Re: AF&PA Comments on W-23-19 Proposal to Add Narrative Surface Water Criteria with Numeric Thresholds for Perfluorooctanoic Acid (PFOA) and Perfluorooctane Sulfonate (PFOS) and Revise the Wisconsin Pollutant Discharge Elimination System (WPDES) Permitting Program

Thank you for the opportunity to comment on the proposed permanent rule WY-23-19 related to establishing water quality standards to minimize the concentration of PFOA and PFOS pollution in surface waters.

The proposed rule (WY-23-19) would revise NR 102, 105, 106, and 219 of the Wisconsin Administrative

ATTACHMENT 1 OF TABLE 1

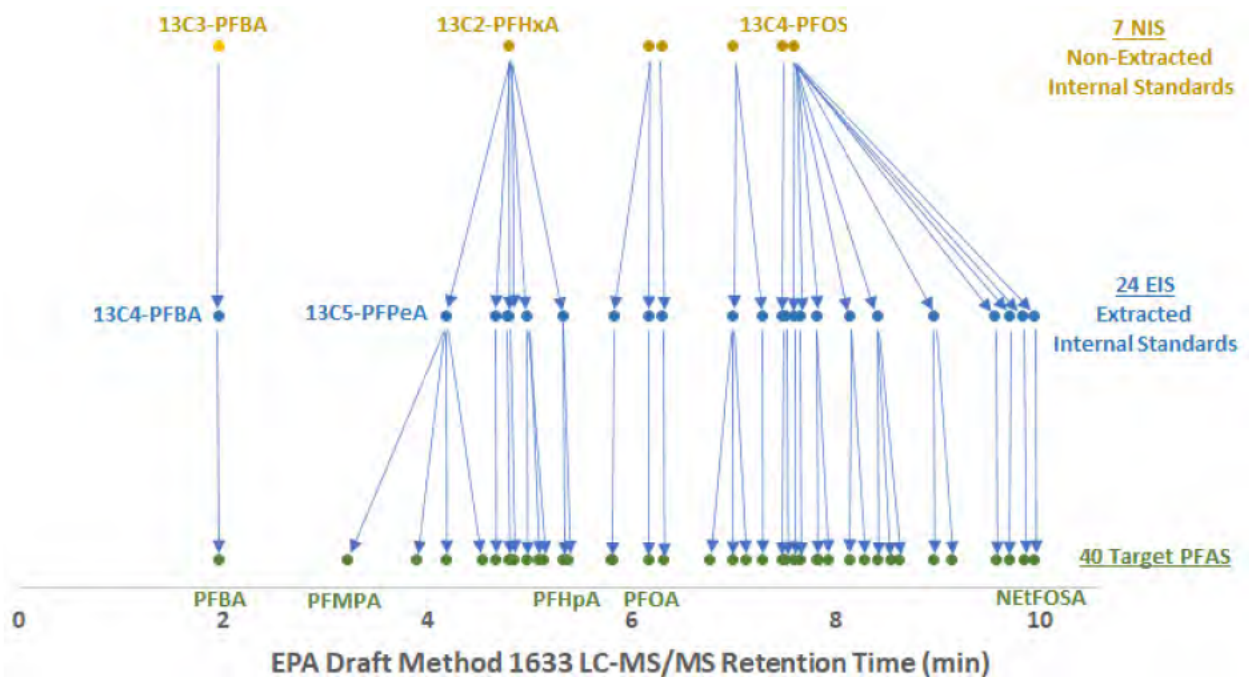
Table 1 Environmental Standards, Inc. Detailed Comments based on Review of Draft Method 1633

Attachment 1: Additional Information for Comment on Section 9.3.3
